RE: Waste Management of Metro Atlanta, Inc.
Pine Bluff MSWLF
Minor Modification – Coal Combustion Residuals (CCR) Management Plan: Local
Government Notifications
Permit Number: 028-039D (SL)

RE: Waste Management of Metro Atlanta, Inc.
Pine Bluff MSWLF
Minor Modification – Coal Combustion Residuals (CCR) Management Plans
Permit Number: 028-039D (SL)

**PINE BLUFF SOLID WASTE MANAGEMENT FACILITY
CCR MANAGEMENT & GROUNDWATER PLANS
PERMIT #: 028-039D(SL)**

LEACHATE
 COLLECTION PIPE
 MAXIMUM
 WASTE DEPTH
 Figure 4-1

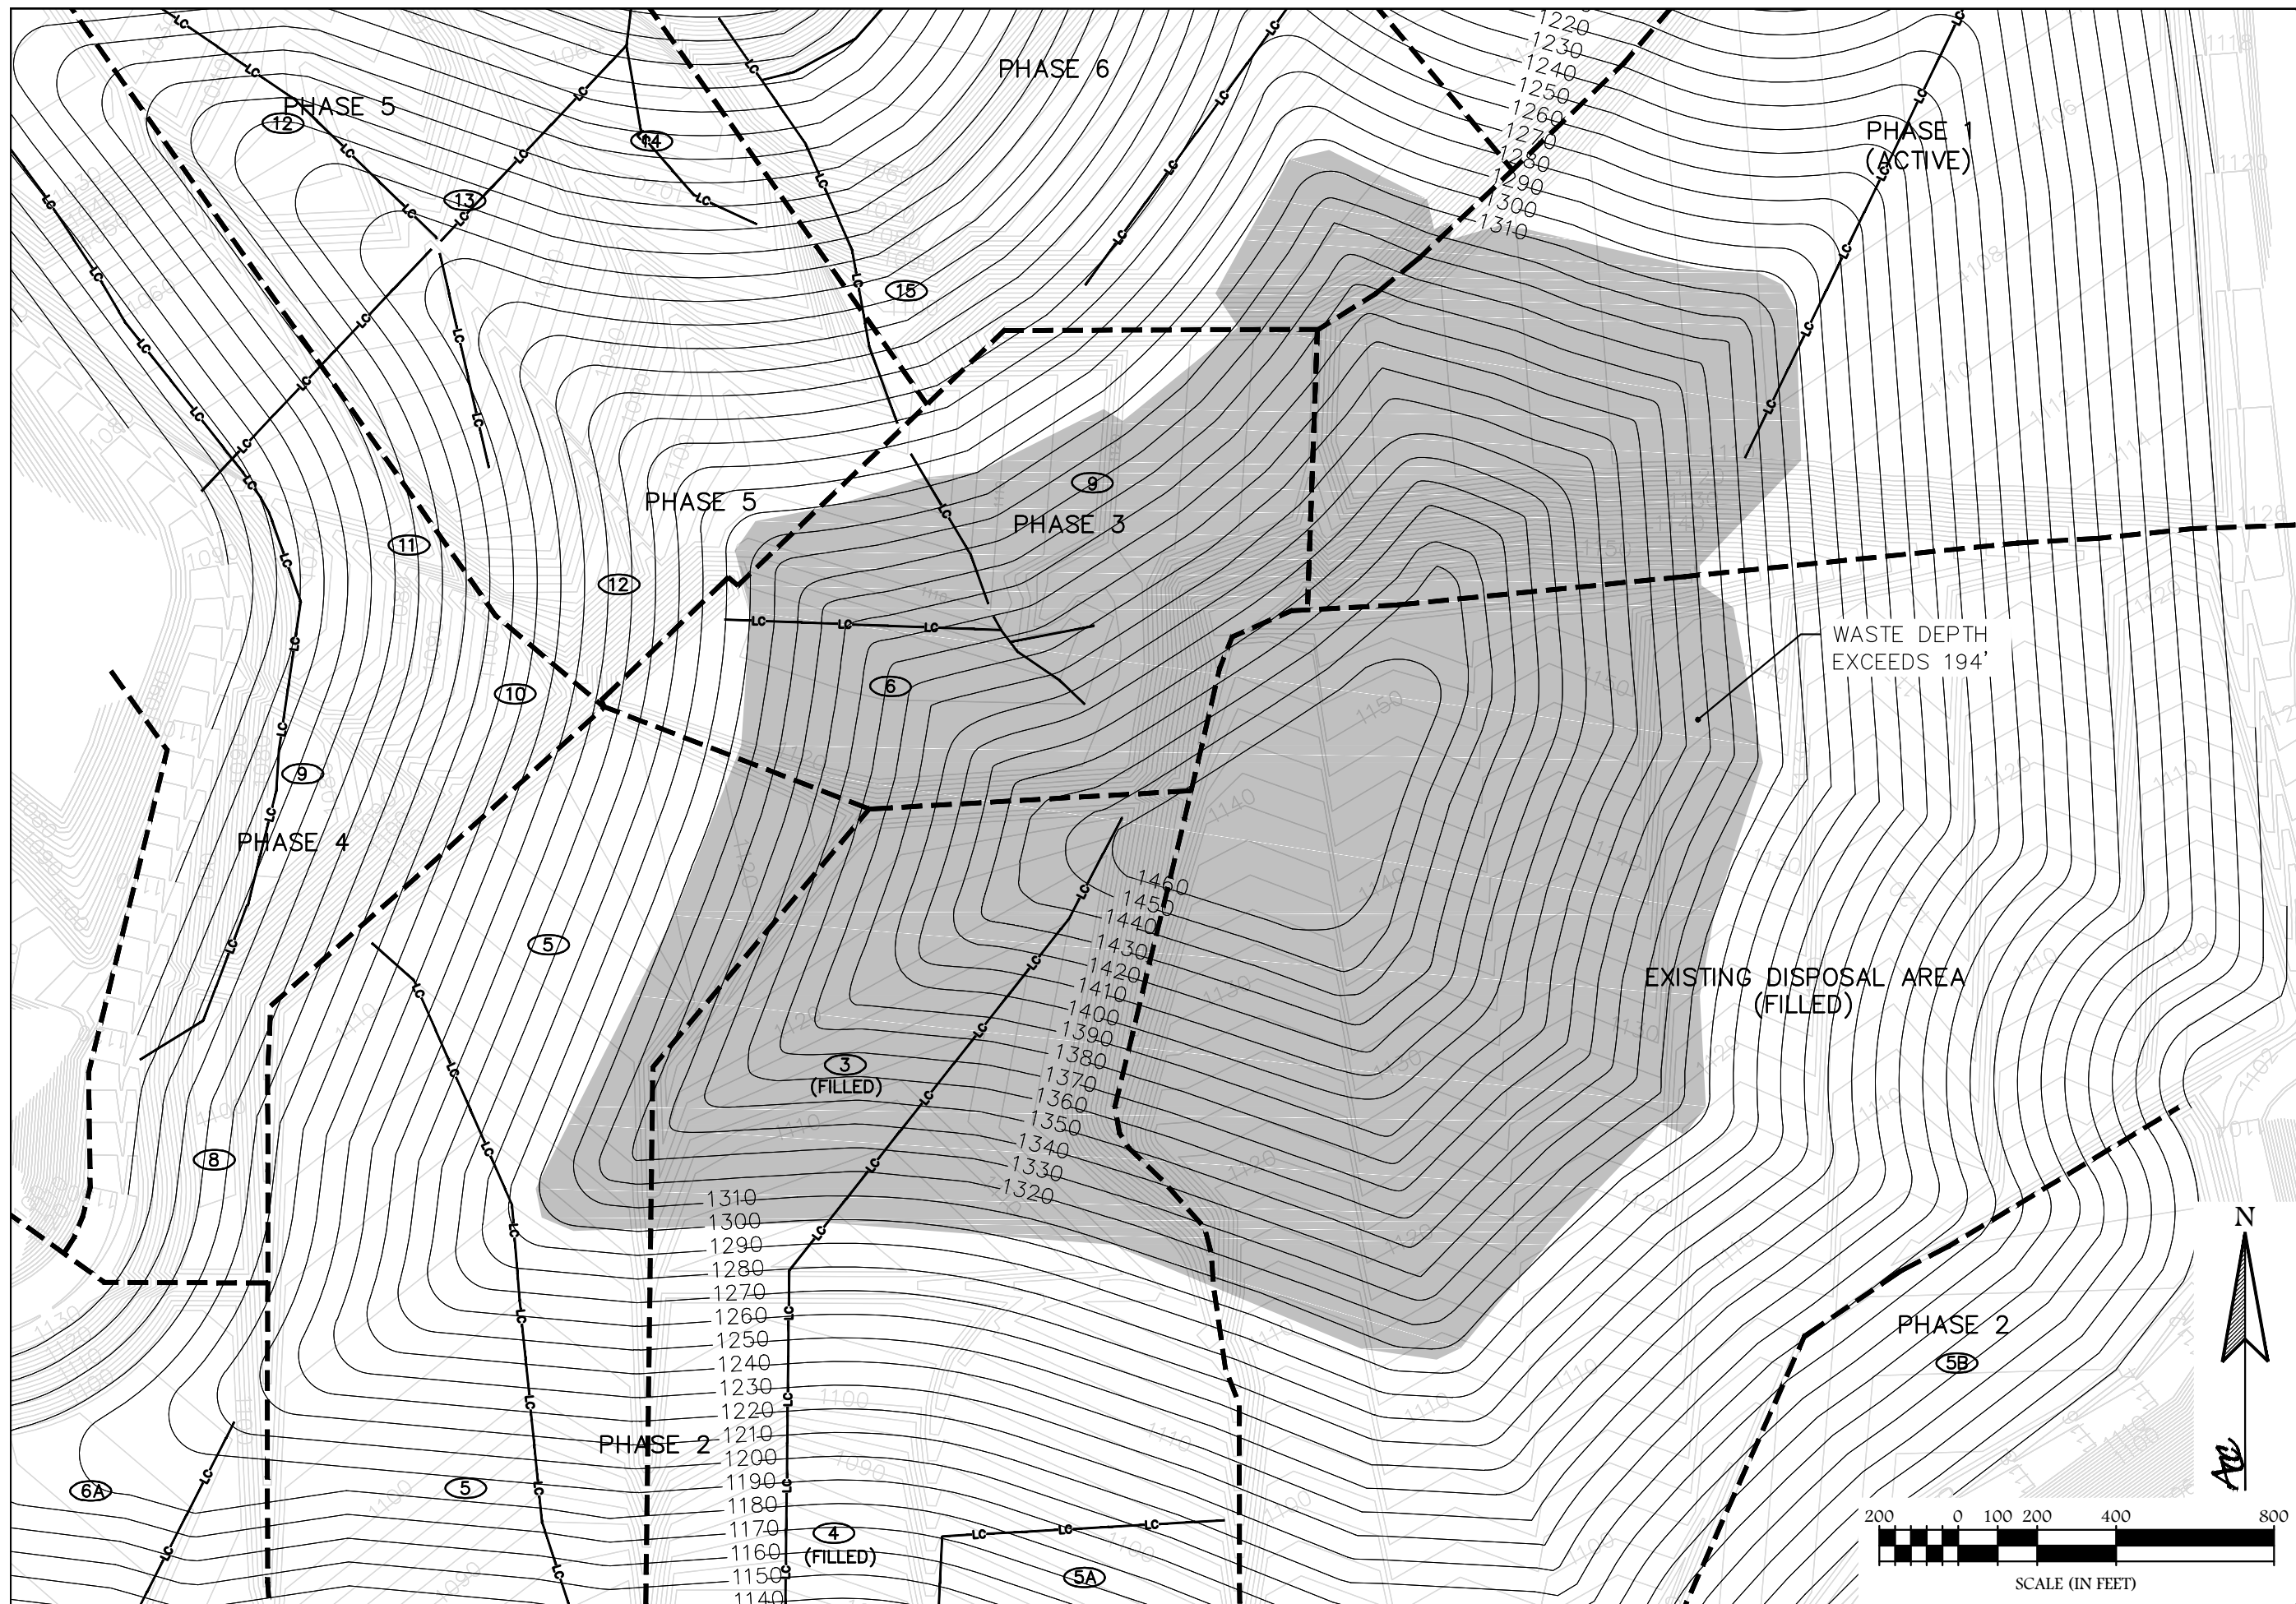
In cells using 6" SDR 17 leachate collection pipes, maximum waste depth (with MSW to CCR ratio by weight of 10:1) is equal to 194 ft. In future Phase 9 cell 23 and Phase 10 cells 24 through 26, the waste depth exceeds 194 ft, therefore, in these cells, the CCR ratio must be decreased or 6" SDR 11 leachate collection pipes must be used (See Figure 4-1). The final waste depths in Phase 1, Phase 2 cell 3, and Phase 3 cells 6 and 9 also exceeds 194 ft (See Figure 4-2). Future disposal of CCR waste will not be allowed in these cells.
